APPLICATION BY AQUIND LIMITED

OPEN FLOOR HEARING STATEMENT ON BEHALF OF THE UNIVERSITY OF PORTSMOUTH

OPEN FLOOR HEARING 1: MONDAY 7TH DECEMBER 2020

30th NOVEMBER 2020

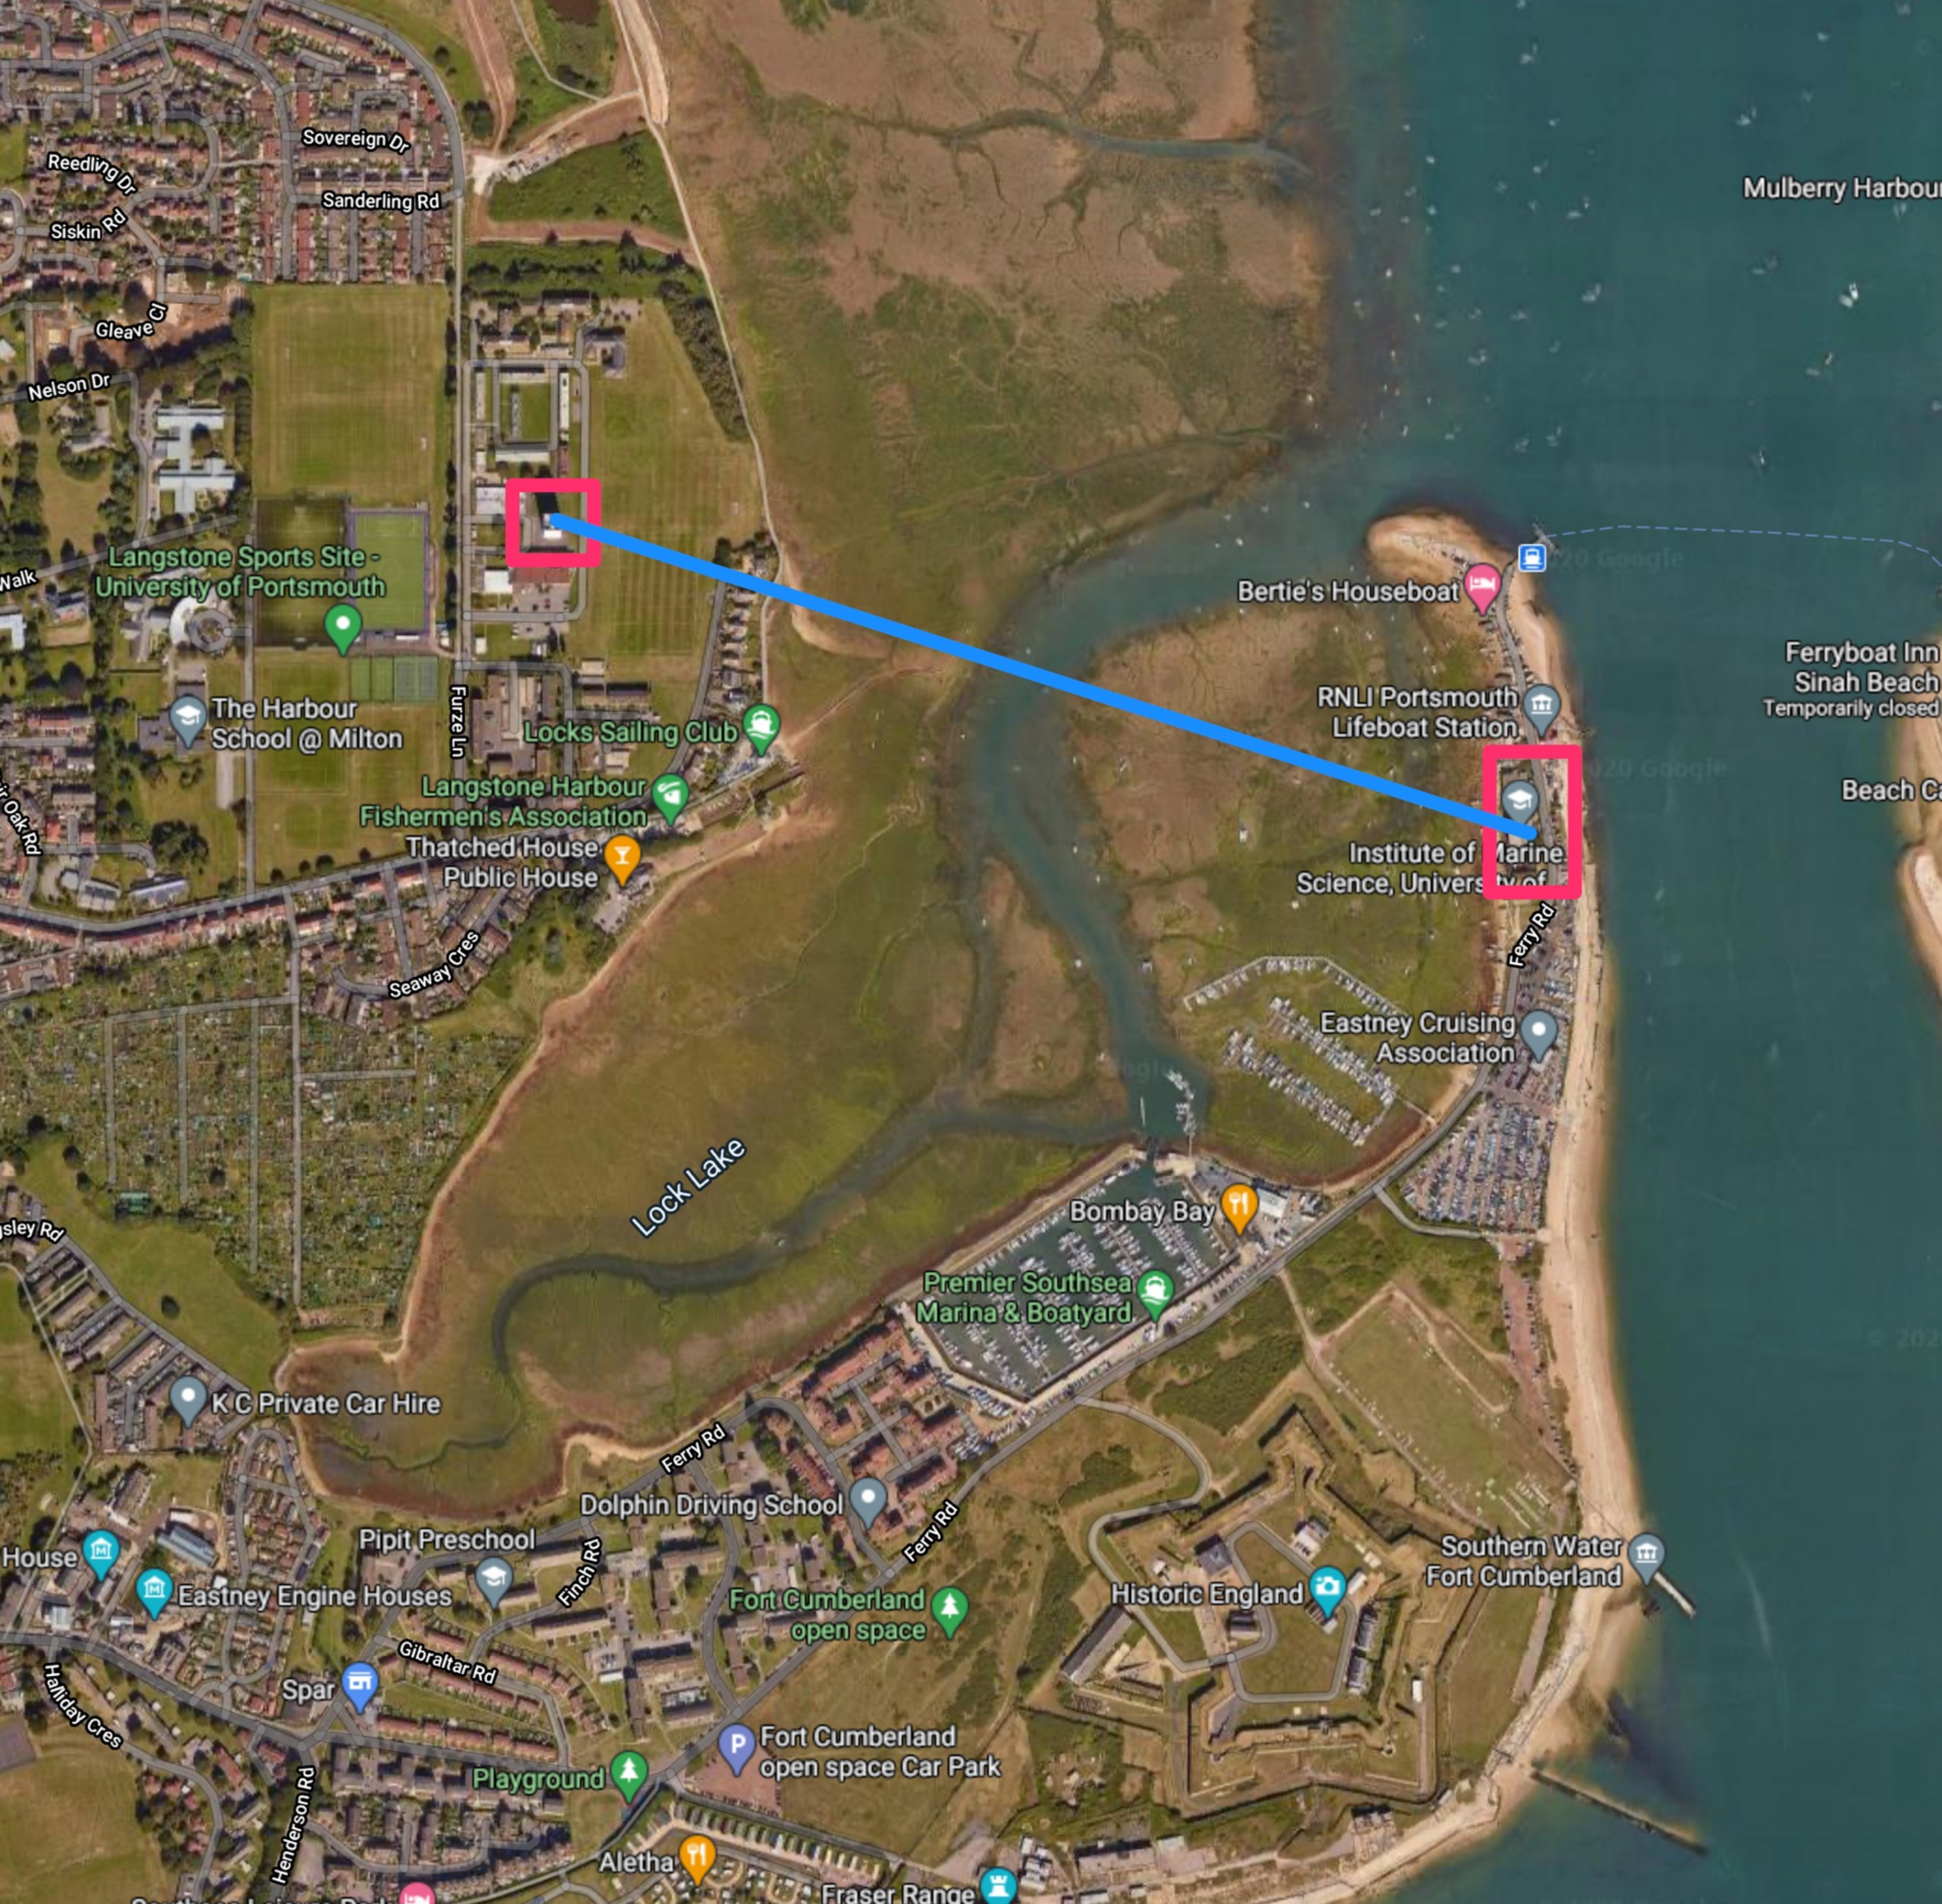
Hi Chris, please see the attached image. It shows the route the wireless signal takes across Langstone Harbour. My concern would be with any large machinery that could generate an electro-magnetic field that could interfere with this wireless link.

Additionally, any large machinery that may cross the path of the link as any blockage would result in disconnections, however this would have to be very high as Barnard tower is at least 12 storeys.

No impact on the IMS link is anticipated as the cables will be shielded. The Environmental Statement – Volume 3 – Appendix 3.7 Onshore Electric and Magnetic Field Report, available at the link below, provides further information on this.
